ADDENDUM #8

PROJECT: 6700 Road Extension
BID NO: 22-026
FROM: Scott Murphy
DATE: January 5, 2023

6700 ROAD EXTENSION
 ADDENDUM NO 8
 MONTROSE, COLORADO
BUTTERFLY VALVE DETAIL

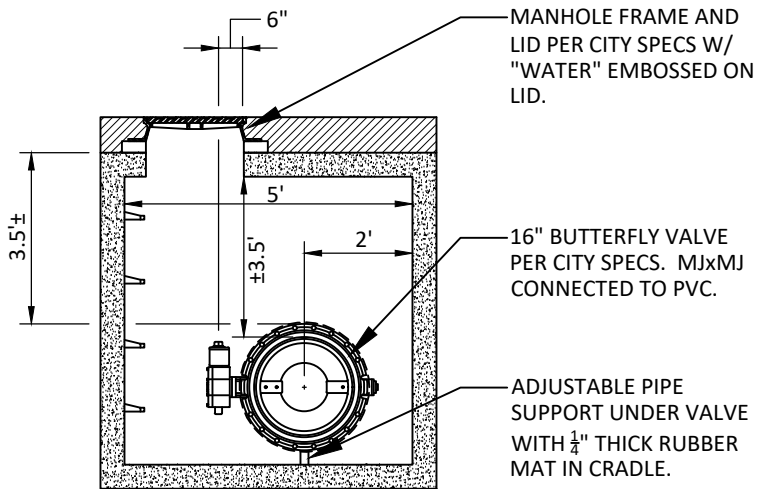
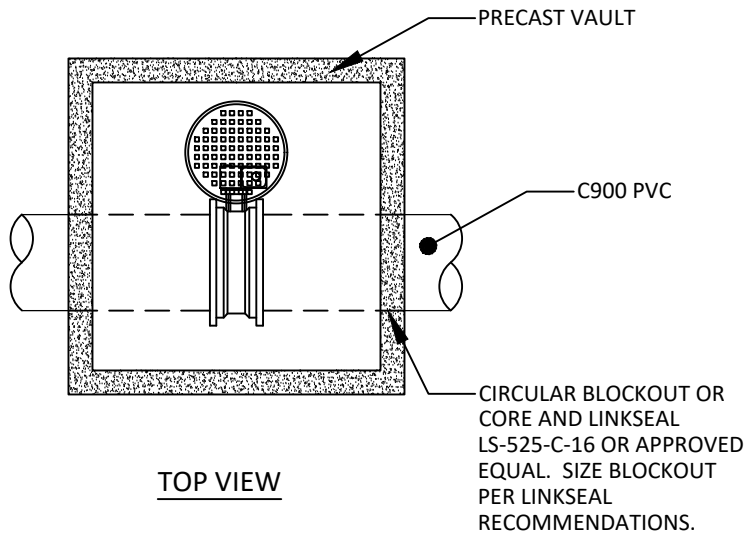
1. *Could you provide more information on the butterfly valve assemblies? The plans did not include a detail.*

Answer: Our apologies, this was an omission from the plans. A butterfly valve detail for this project is included as an attachment to this addendum and these will be incorporated into the issued for construction plans. Payment for the butterfly valve line item shall include the valve, associated hardware, pipe support, vault, link-seals, excavation, and vault leveling gravel.
